# Work Order ID 99884

Item Name: Crosstube Turning Detail

DRAWING NO. D212-664-241	TITLE CROSSTUBE ASSY. (205/212 HI AFT)	REV. D	DART AEROSPACE LTD ENGINEERING ORDER		D.E.O. NO. D212-664-241-D-1	SHEET NO. SHEET 1 OF 2	SCALE NTS
DRAWN	CHECKED	MFG. APPR.	APPROVED	DE APPR.			
DATE 11.04.07	DATE 11.04.11	DATE 11.04.12	DATE 11/04/12	DATE 11.04.12

ADD AN INSPECTION WINDOW TO UNDERSIDE OF CROSSTUBE.

D212-664-241/-241B  
ASSEMBLY DETAIL

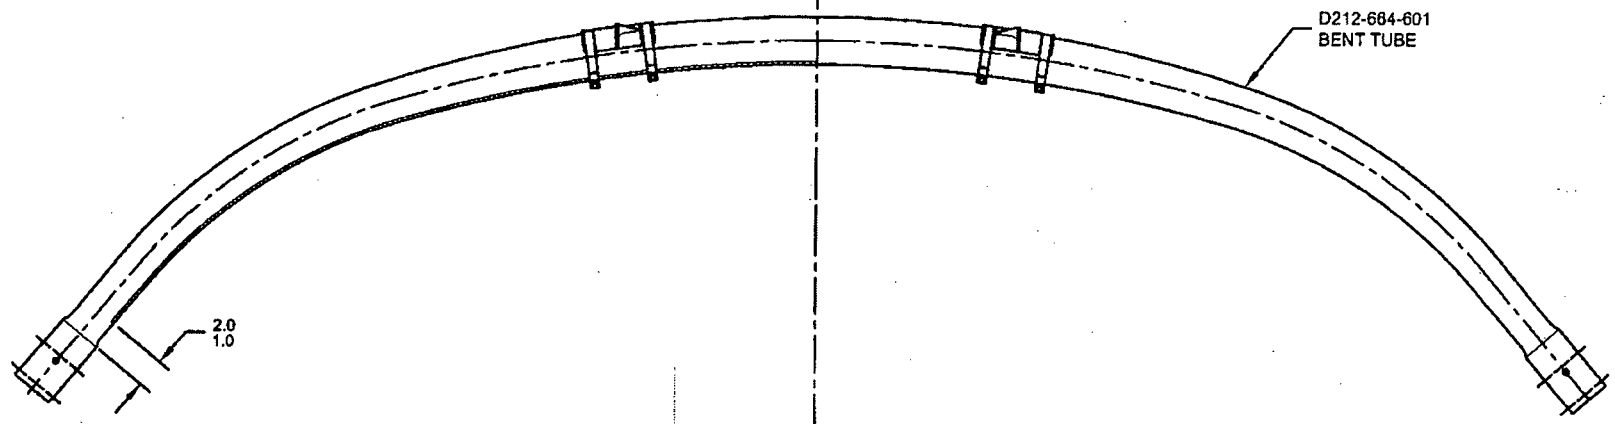
NOTES 2 OF SHEET 1 IS AMENDED AS FOLLOWS:

IS:

WAS:

- 2) FINISH: CHEMICAL CONVERSION COAT PER DART QSI 005 4.1  
PRIME INSIDE AND OUTSIDE PER DART QSI 005 4.2  
MASK UNDERSIDE OF CROSSTUBE AS SHOWN (HATCHED AREA) AND  
PAINT OUTSIDE PER DART QSI 005 4.2  
REMOVE MASKING AND APPLY CLEAR COAT

MASK AREA PRIOR TO PAINTING,  
REMOVE MASKING AFTER PAINT  
AND APPLY CLEAR COAT
